Access Compliance Report

Public Rights-of-Way

(Curb Ramps)

Intersection ID: 31215	Main Street: OLDEHURST_PL	Cross Street: WRAYHILL_DR	Location: NE
ADA ID: CE7411498102	Ramp Type: PerpDiag	Initial Pass/Fail: Fail	Overall Compliance: No
		Severity Score: 8.75

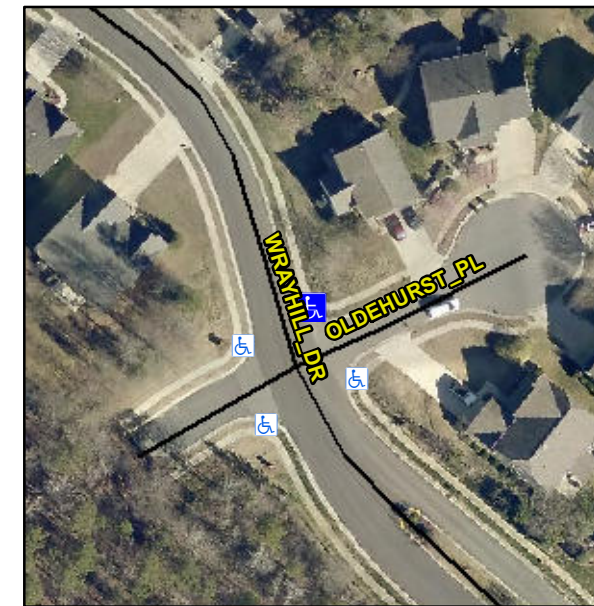
Not Found, R304.5.1

Remove & Replace Curb Ramp With Two New Directional Ramps or Equivalent.
